REVISION LEGEND
(AUGUST 2018)

CHANGES TO SCHEME FOR DENOTED FOR PLANNING

Archer Humphryes Architects

project title		KOKO + Hope & Anchor + Bayham Place Camden, London	
drawing title	scale	date	
Proposed Third Floor Plan	1:100 A11	13.04.17	
drawing number	drawn / checked	FR/PC	DA
revision	1		
drawing number		AHA/KKC/GA/103

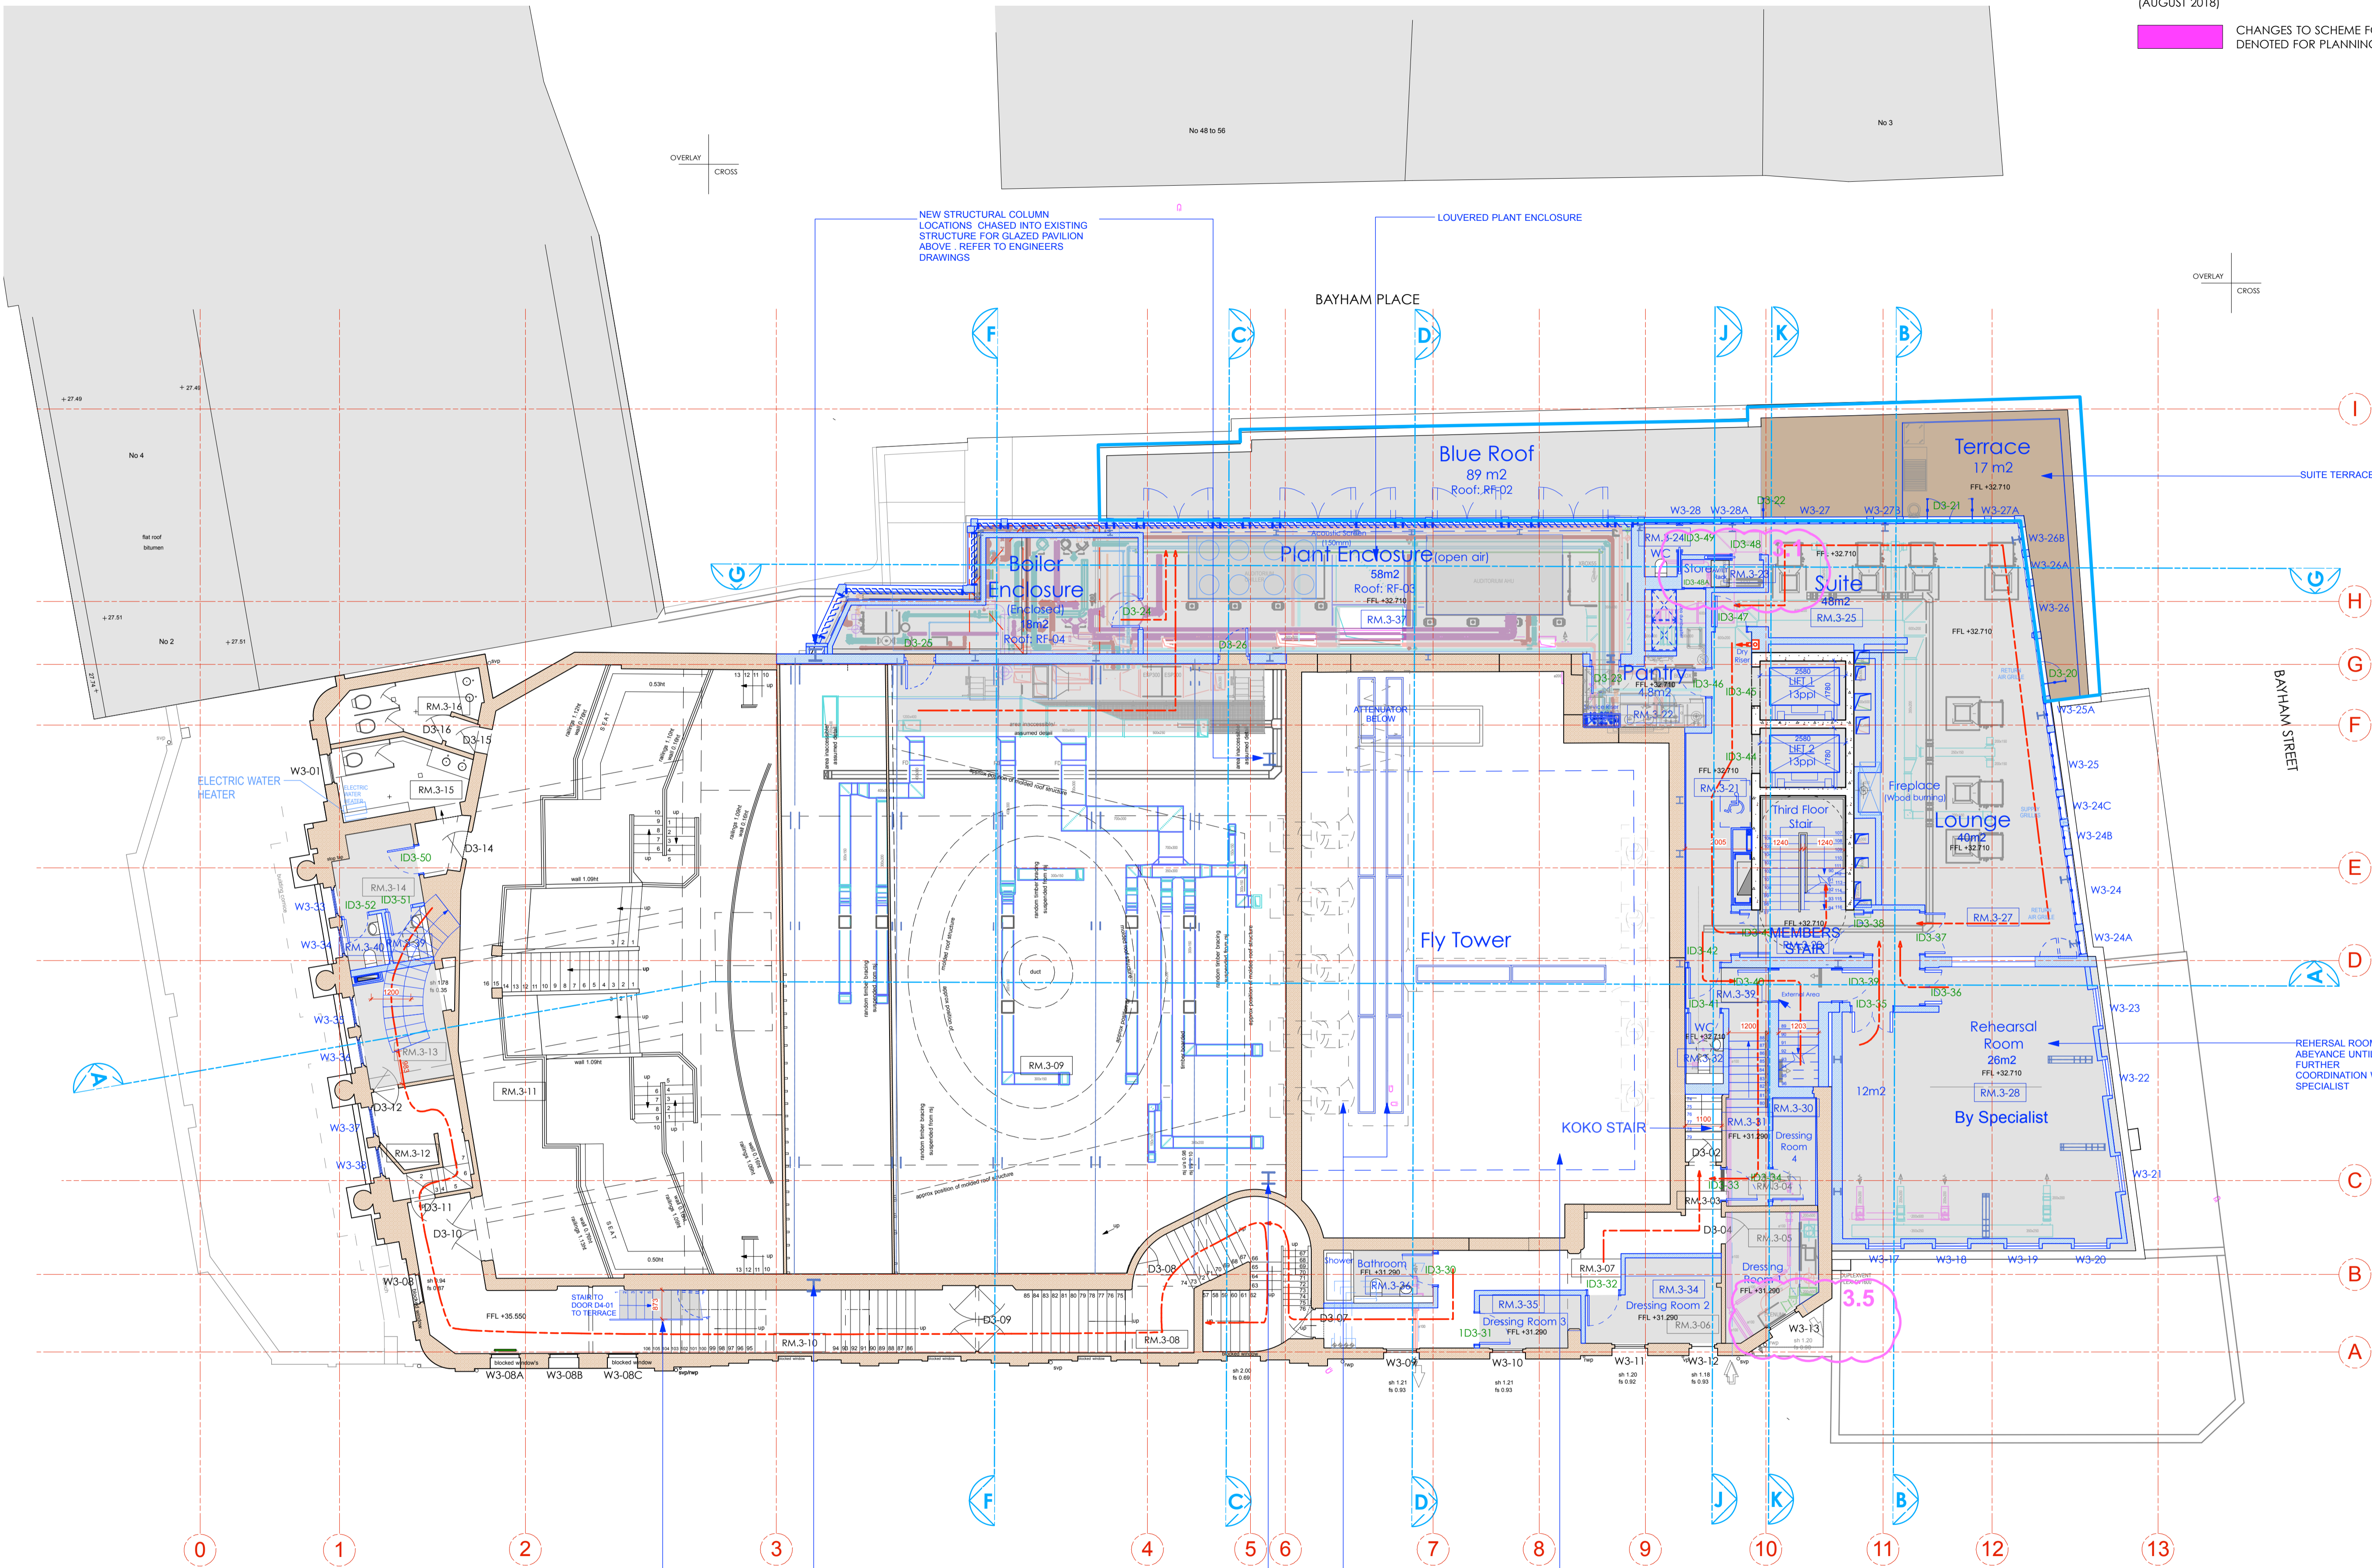
revision / date / amendments	
- / 26/01/18 /	- First Issue
A / 02/02/18 /	- WC indicated under Dome.
B / 01/03/18 /	- Windows numbers updated in line with window schedule.
C / 23/03/18 /	1. Tender Addendum (1), indication of 4 post truss fixed at stage level for integrated automatic retractable acoustic baffles and integrated lighting rig. 2. Tender Addendum (2), New AHU + Attenuator over stage to be hung to existing relocated secondary beams in Flytower.
D / 09/04/18 /	- Alterations to 3rd floor ID layout.
E / 12/04/18 /	- Window and door numbers updated.
F / 01/06/18 /	1. Indication of 4 post truss fixed at stage level for integrated automatic retractable acoustic baffles and integrated lighting rig. 2. New AHU + Attenuator over stage to be hung to existing relocated secondary beams in Flytower.
G / 05/07/18 /	- Updated stage 4 fit out interior and kitchen layouts.
H / 31/07/18 /	3.1. AV/IT rack room added with cooling. 3.5. Ventilation grille for fresh air to dressing rooms.

I / 15/08/18 /	- Colour coding added to revised drawing Rev H
